Millstone Nuclear Power Station, Unit No. 3  
Transmittal of Amendment to FSAR/ER  
Docket No. 50-423

Millstone Nuclear Power Station, Unit No. 3  
Transmittal of Amendment 4  
to the Environmental Report

As committed in Reference (1) and in accordance with 10 CFR 50.30 (c)(1)(iv), Northeast Nuclear Energy Company, herewith submits Amendment 4 of the Environmental Report (ER).

FIGURE Q240.1-4  
INTAKE STRUCTURE  
SITE ALTERATIONS  
MILLSTONE NUCLEAR POWER STATION  
UNIT 3  
ENVIRONMENTAL REPORT  
OPERATING LICENSE STAGE

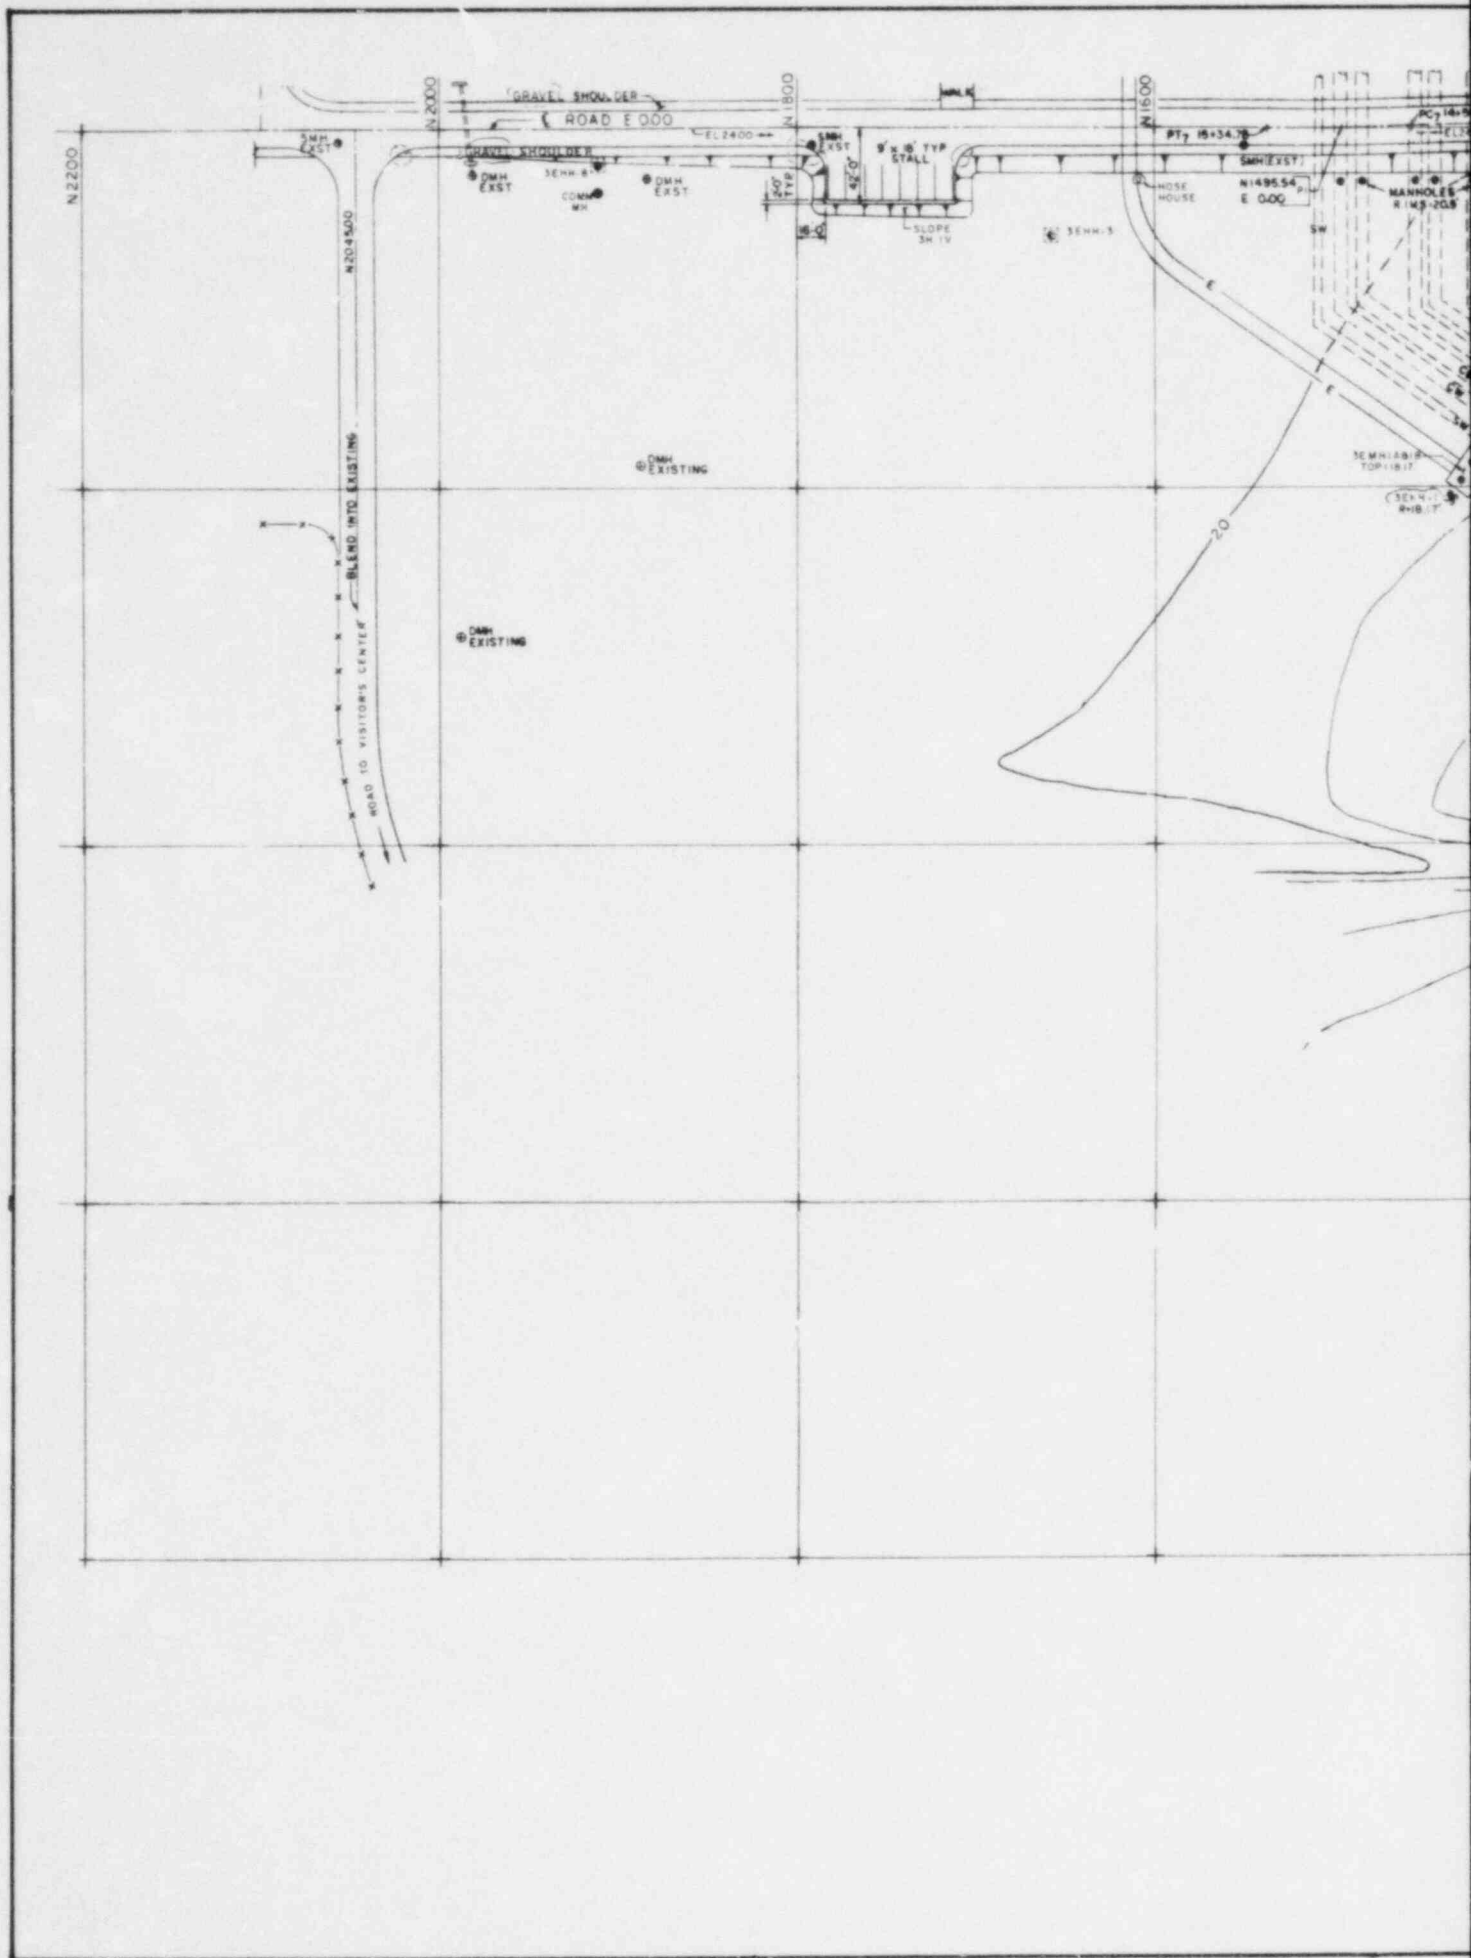
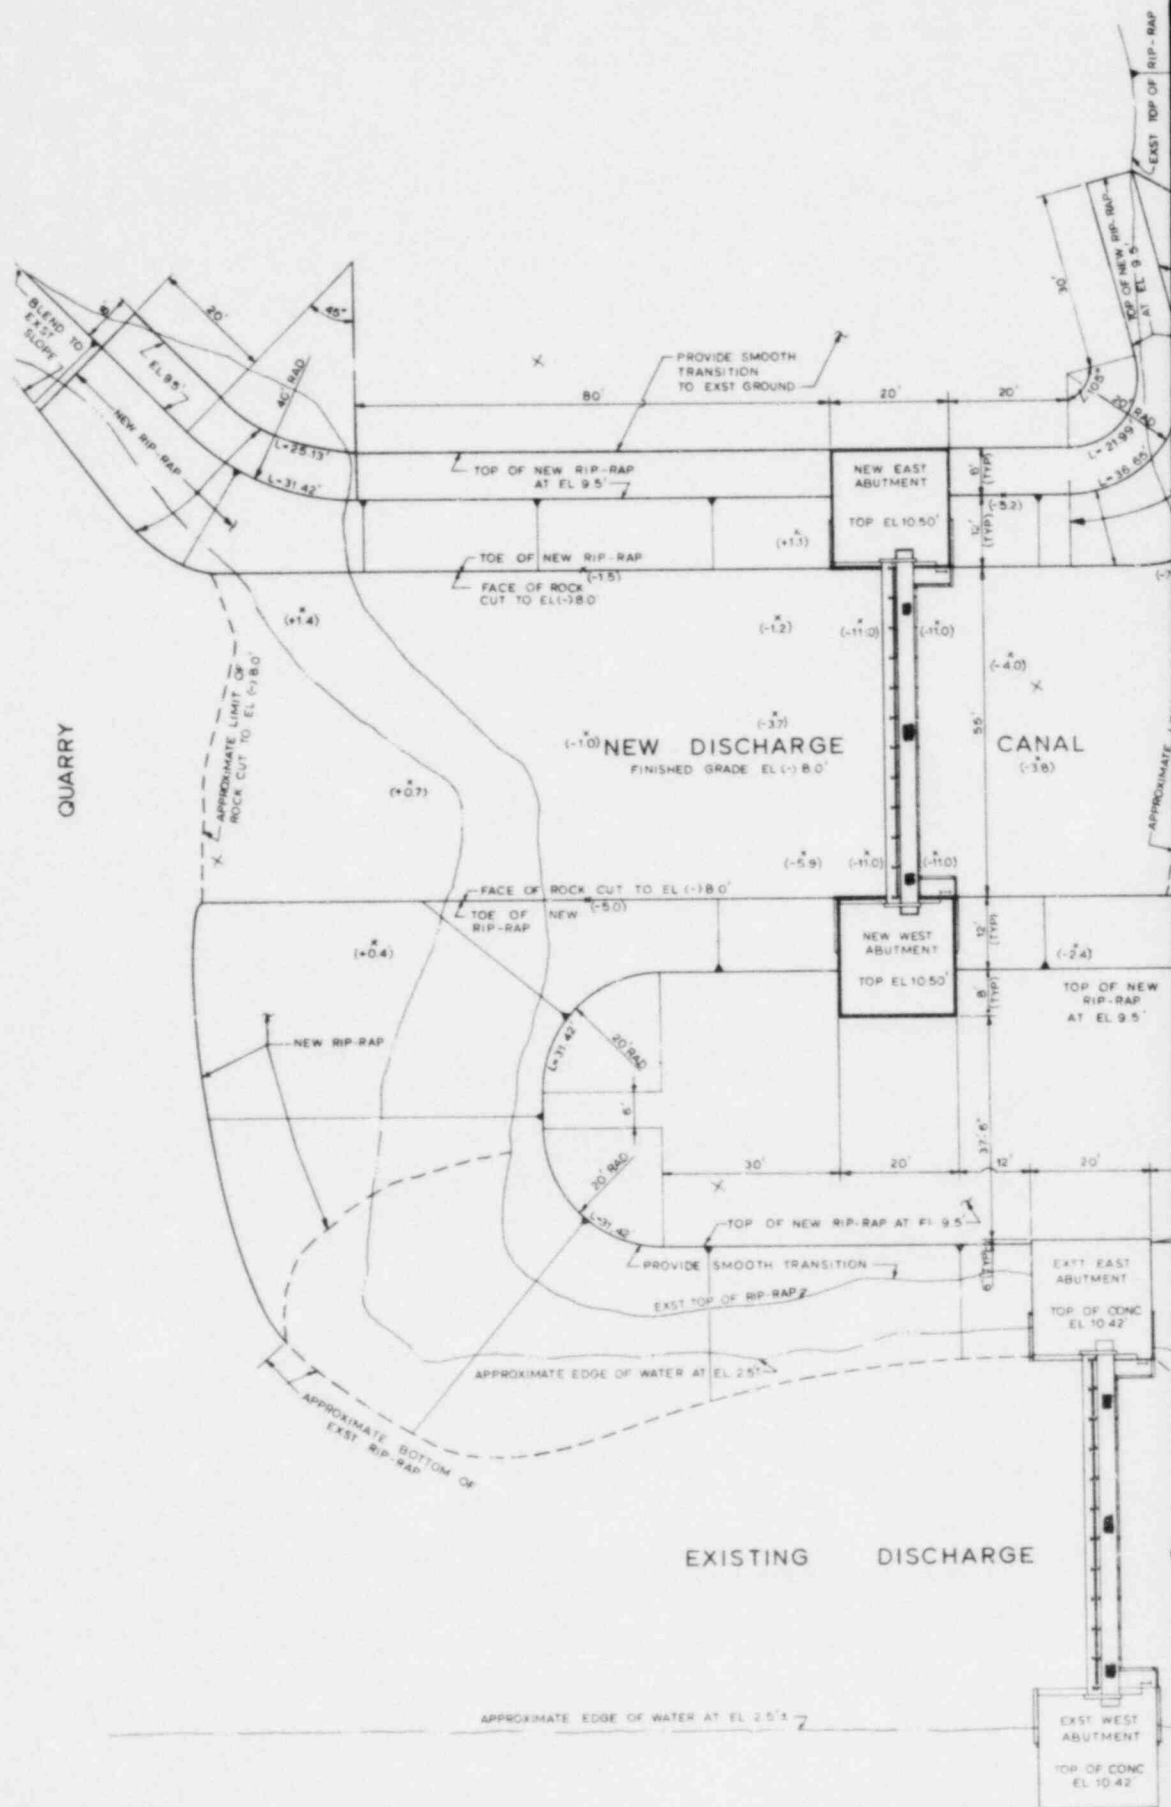
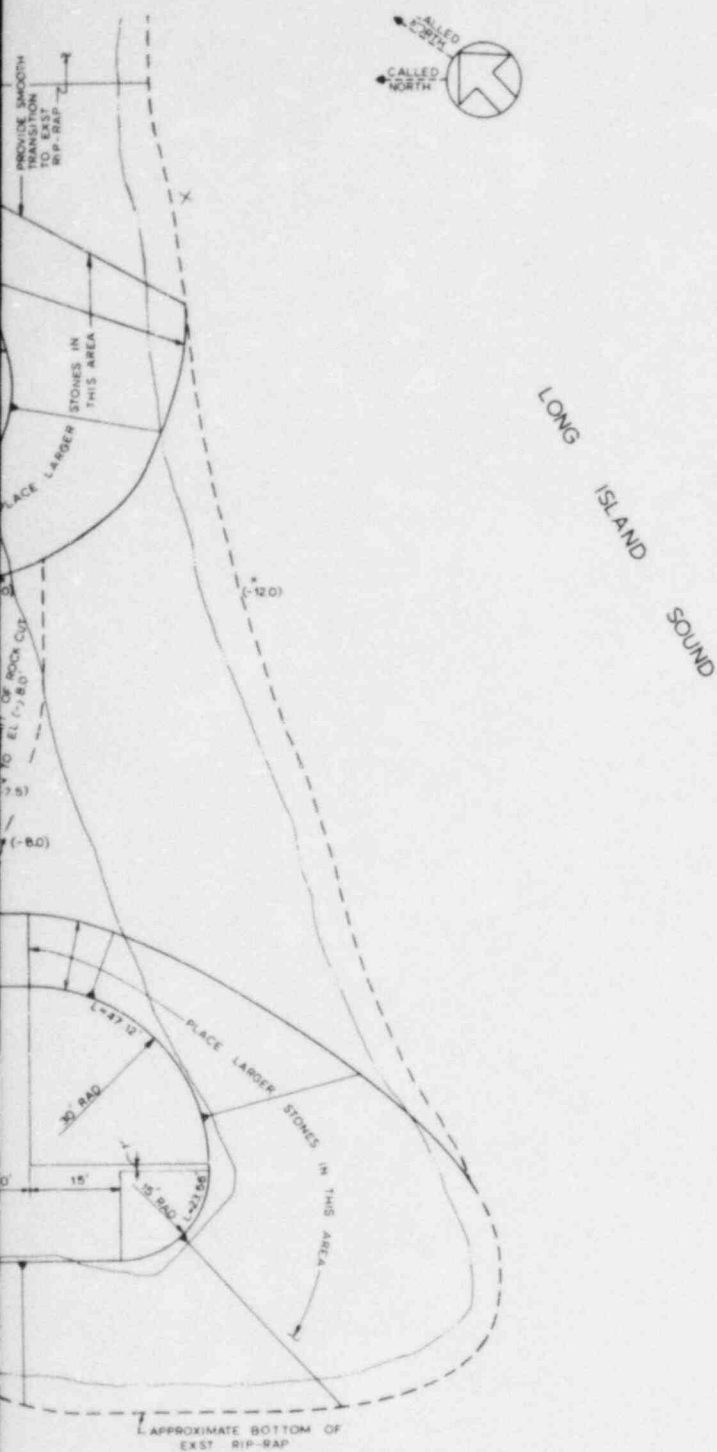
- c. Identify, locate on a map and describe all plant structures and topographic alternations in the floodplains.
- d. Discuss the hydrologic effects of all items identified in response to c. above. Discuss the potential for altered flood flows and levels, offsite. Discuss the effects on offsite areas of debris generated from the site during flood events.

- c. Figure Q240.1-2 shows the floodplain with plant structures in place. The outfall structure, the circulating and service water pumphouse, and the new discharge canal are partially in the floodplain. Details of site grade revisions for these three facilities are given in Figures Q240.1-3, Q240.1-4, and Q240.1-5.
